DESIGN COMMITTEE MEETING
4:30 p.m.
Civic Center Meeting Room 1 & 2
Roseville, California
www.roseville.ca.us

- 1. CALL TO ORDER**
- 2. ROLL CALL**
- 3. CONSENT CALENDAR**
 - 3.1. Minutes of December 20, 2018
- 4. REQUESTS/PRESENTATIONS**
 - 4.1. Design Review Permit – Infill Pcl 285 – Milo's Sand and Gravel – 1801 PFE Road – File # PL17-0130

The applicant requests approval of a Design Review Permit to develop two (2) vacant parcels totaling 2.8 acres into a landscaping materials and supplies retail site. The site will consist of 77 storage bins and a 1,066 square-foot retail sales office building with associated parking, lighting, and landscaping.

Figure 2: East and West Elevations

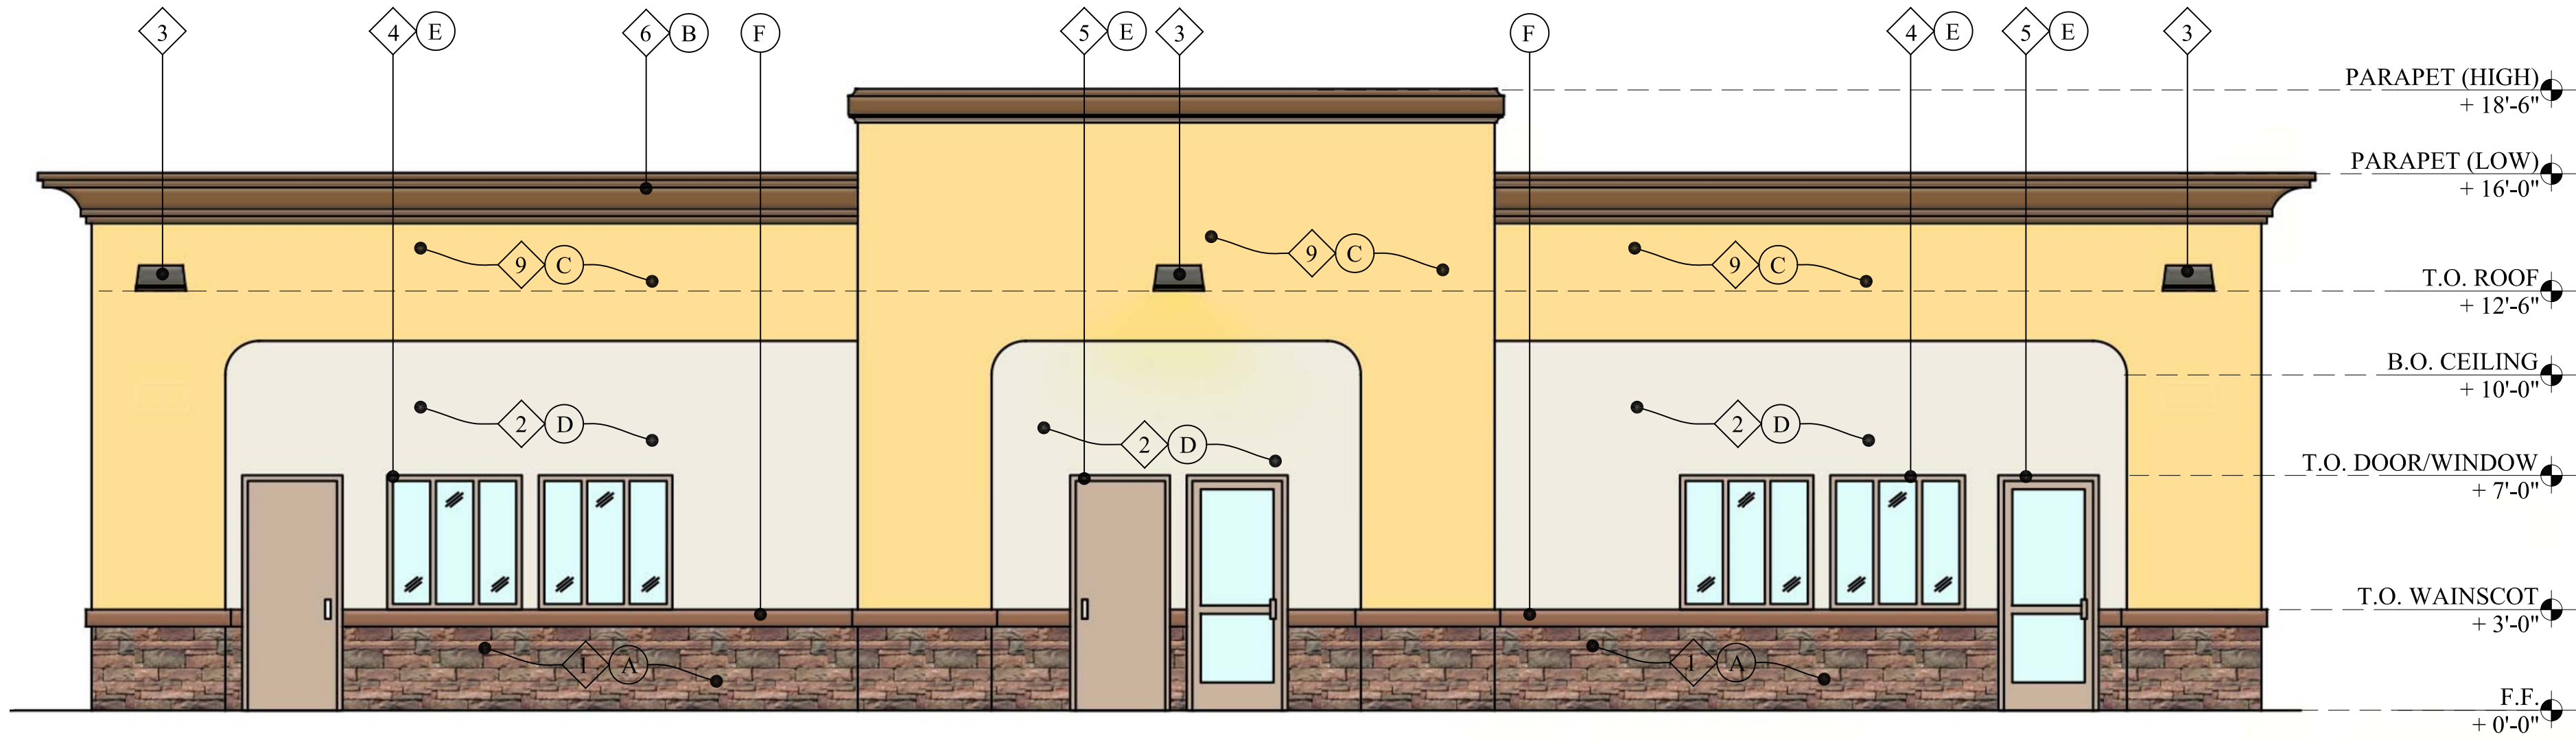
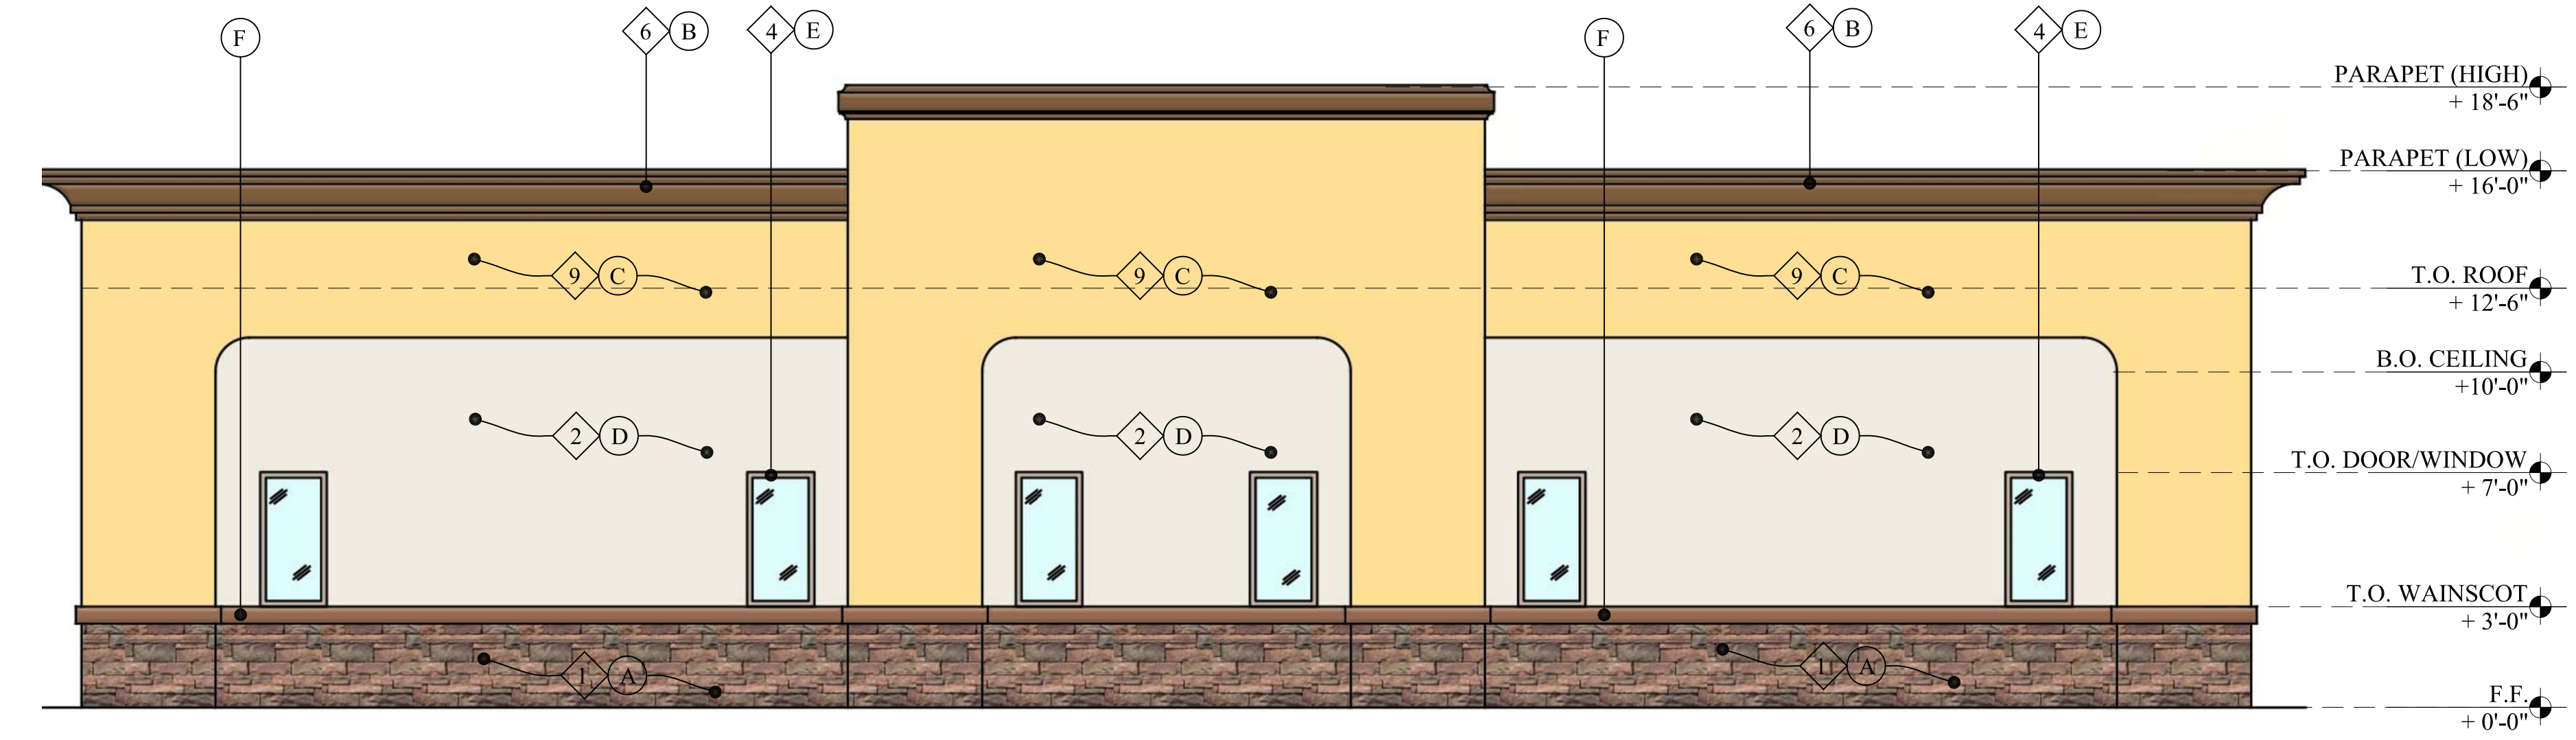
The building roof lines vary in height from 16 feet to 18.5 feet to provide greater variation in the wall planes. In addition, the center of the building will project out two (2) feet to add visual depth to the façade.

The proposed design features are consistent with the CDG, which call for variations in wall planes and building form (Policy OI-34), variation in colors and materials (Policy OI-39), and elements such as cornice treatments to enhance the façade and building form (Policy OI-41).

SHEET L-1 of 3

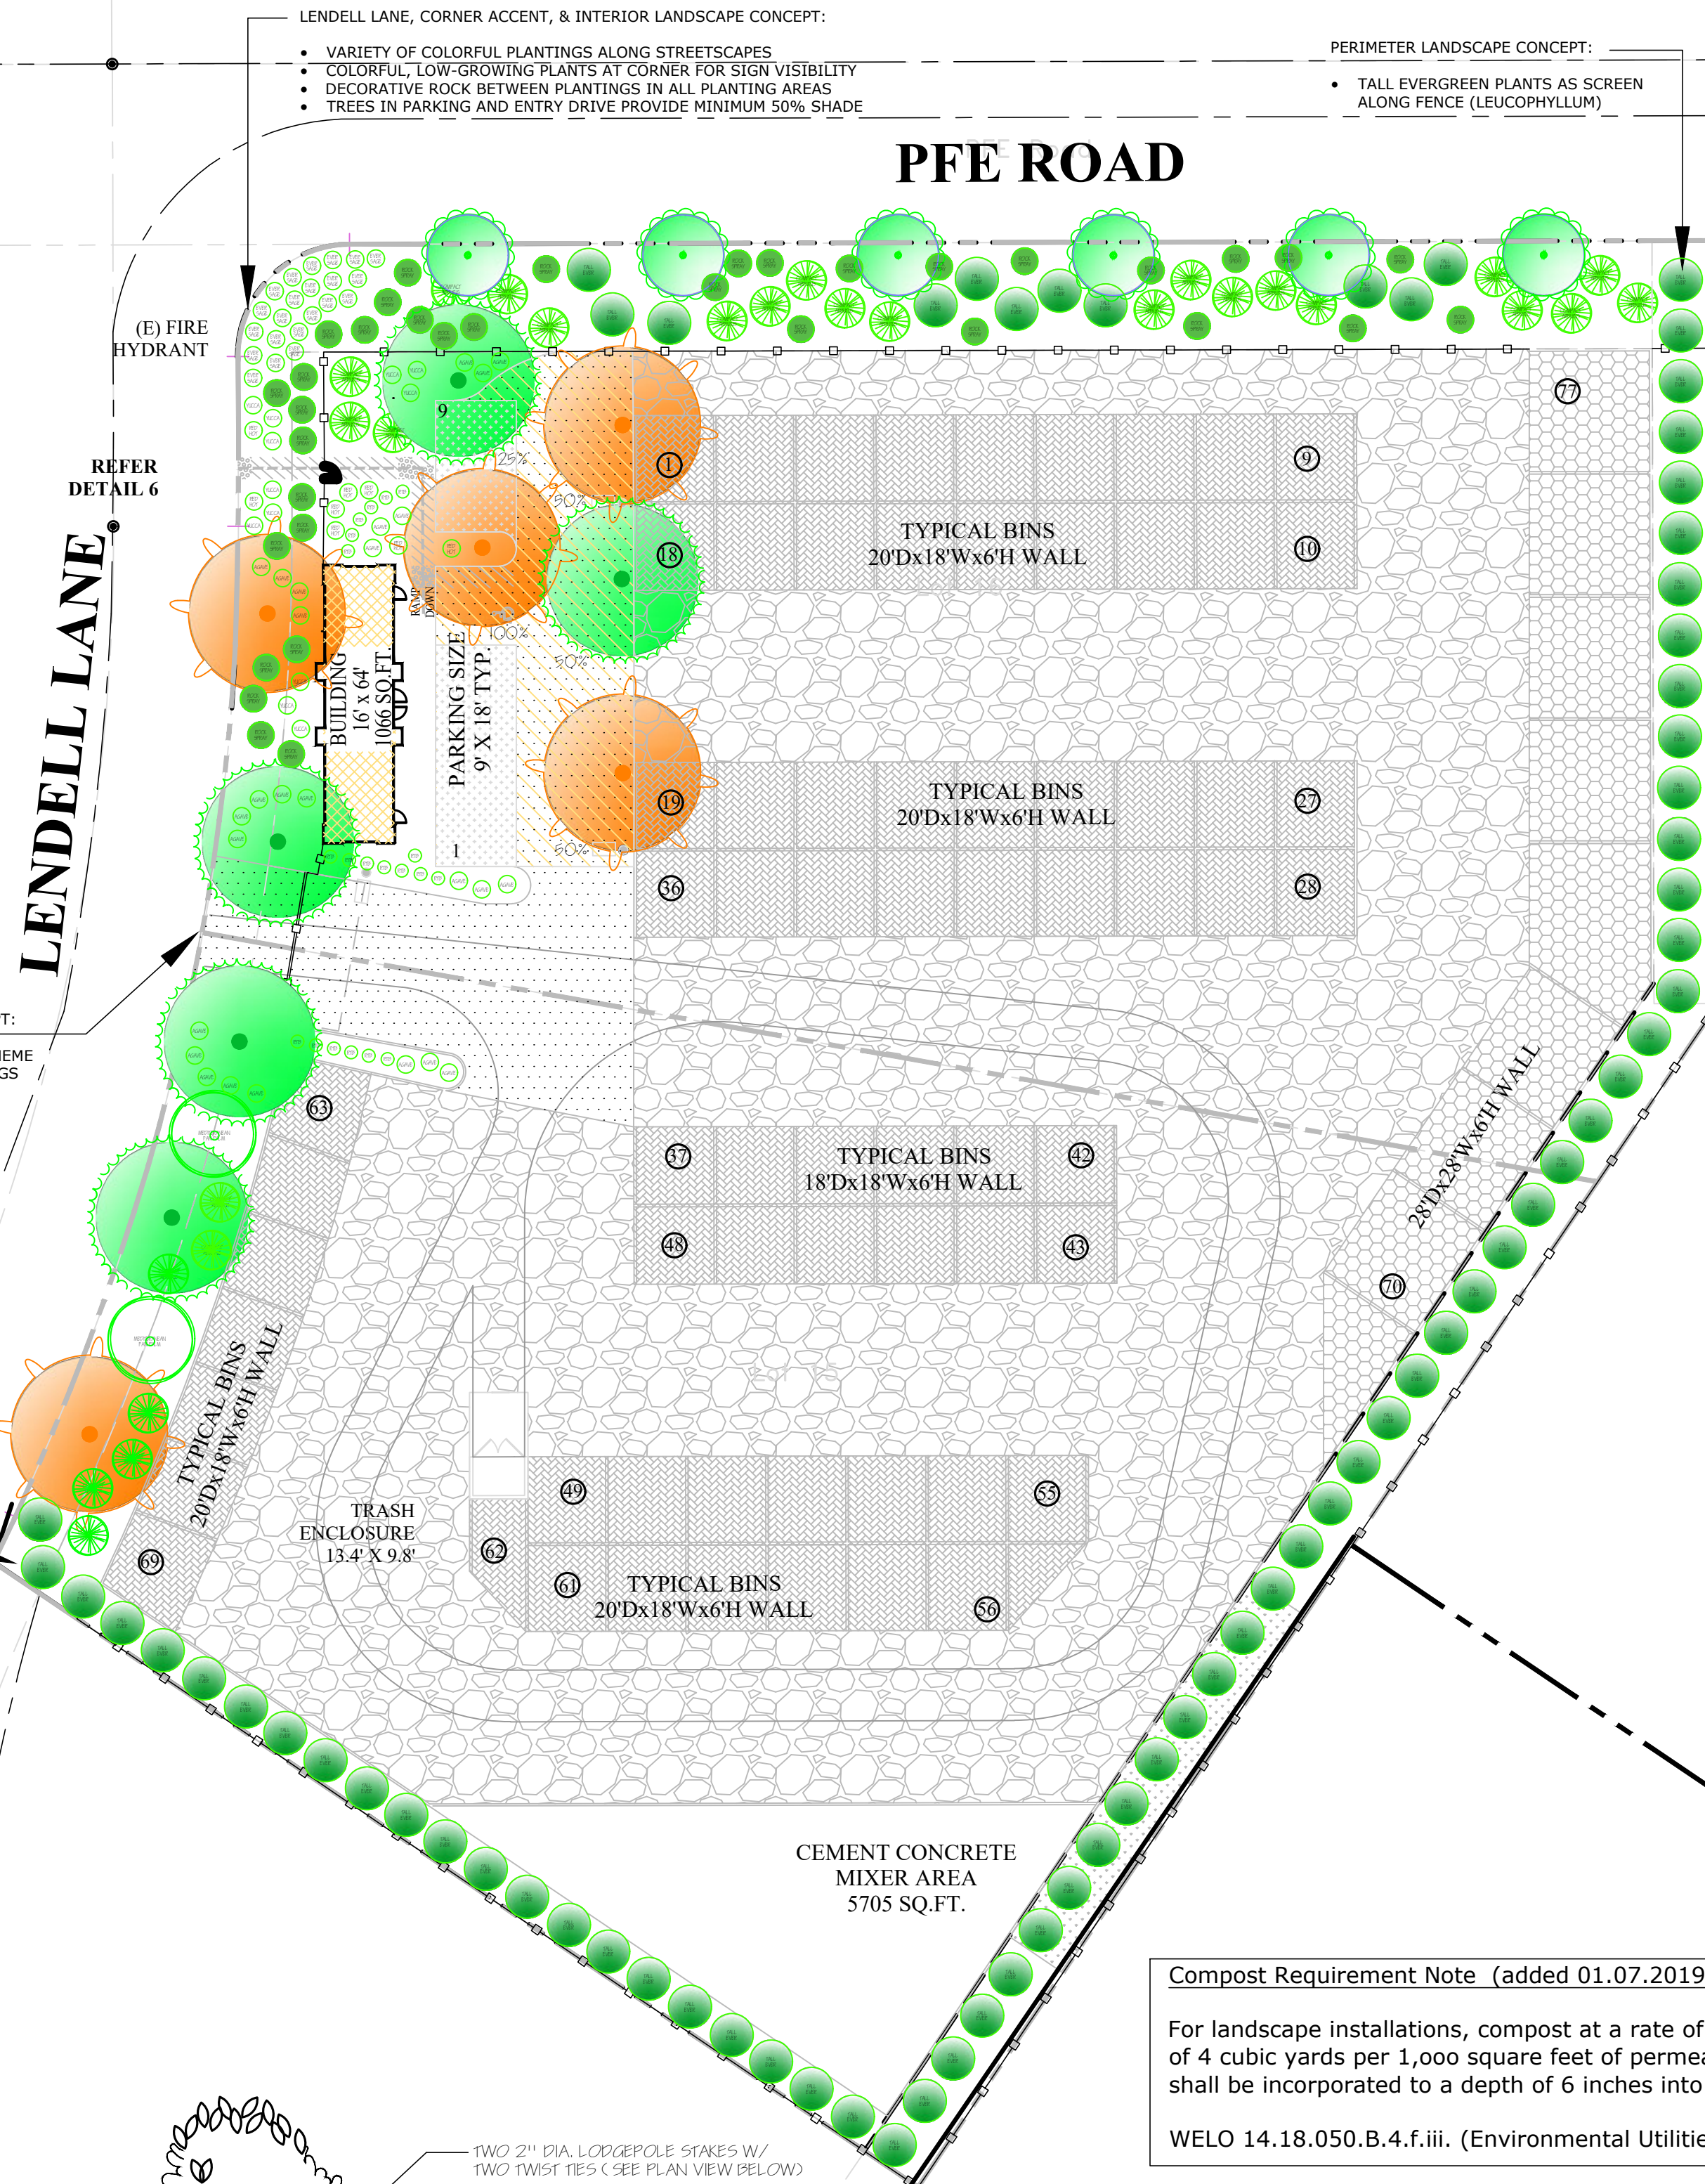
The proposed landscape plan demonstrates that the proposal exceeds the City's minimum requirement of 50% shading in parking lots. However, three of these trees (located adjacent to the bins) are not located within an adequate planter area. Per Policy OI-61 of the CDG, tree selection and placement should allow for sufficient root space adjacent to paved surfaces and identifies that a planter width of eight (8) feet (measured inside curbs) should be provided for medium to large canopy trees. As such, Condition #12h has been included to require these trees be located in an 8-foot wide planter to prevent damage and ensure they adequately grow.

- g. The proposed cork oak trees shall be replaced with London Plane trees. (Planning)
 - h. Trees shall be located within a minimum planter width of eight (8) feet (measured inside curbs). (Planning)
